SEWAGE DISPOSAL TESTING

STATE OF MARYLAND - DEPARTMENT OF HEALTH AND MENTAL HYGIENE

A 31137
P _____

RE: Henry H. Harjes property
Parcel 2, Route 108
Clarksville, Maryland

1A-1
SOIL PROFILE

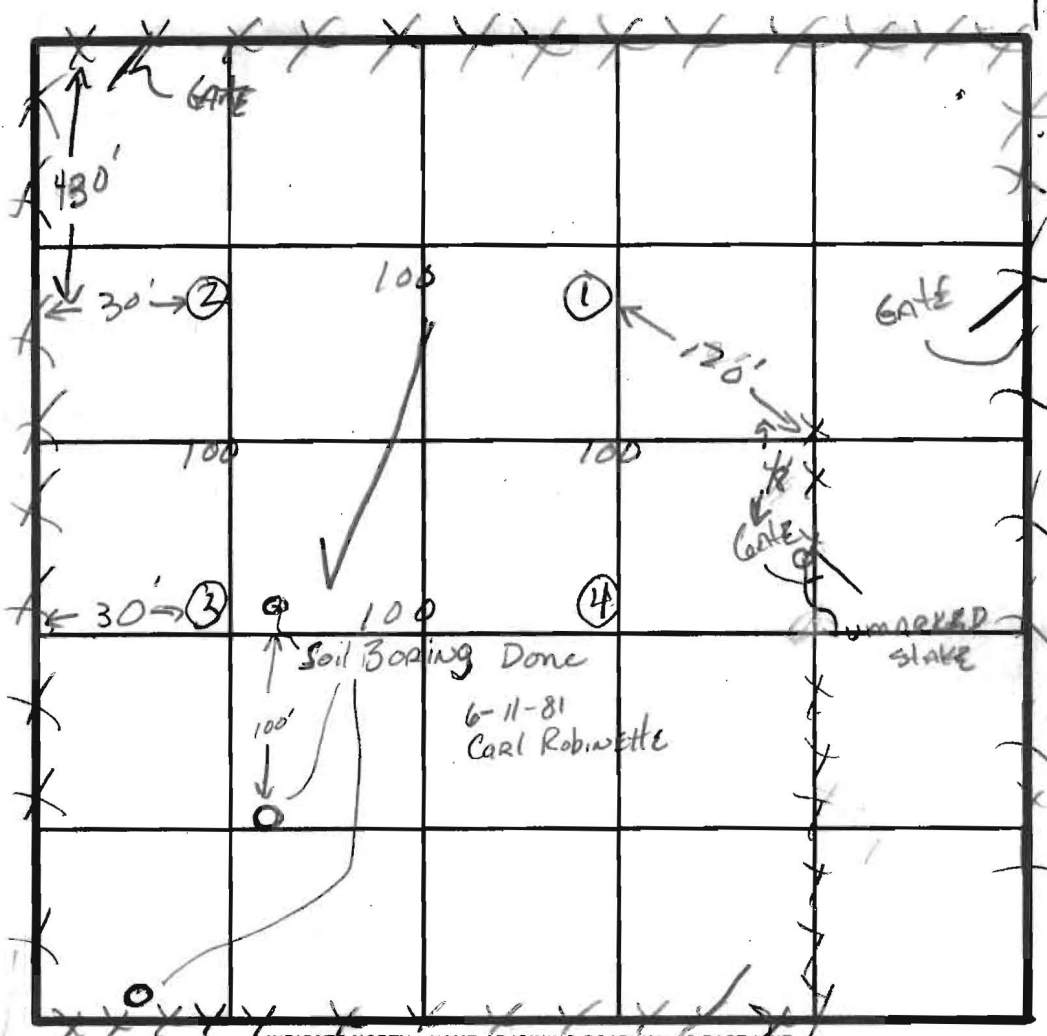
REASONS FOR REJECTION OR HOLDING shutted soil, hold for wet season
test OK 3/3/81

REMARKS 6/11/81 Soil test borings accomplished (see sketch) J. Covalt S. Kiel Carl Robinette, R. Ziehm & F. Skinner present.
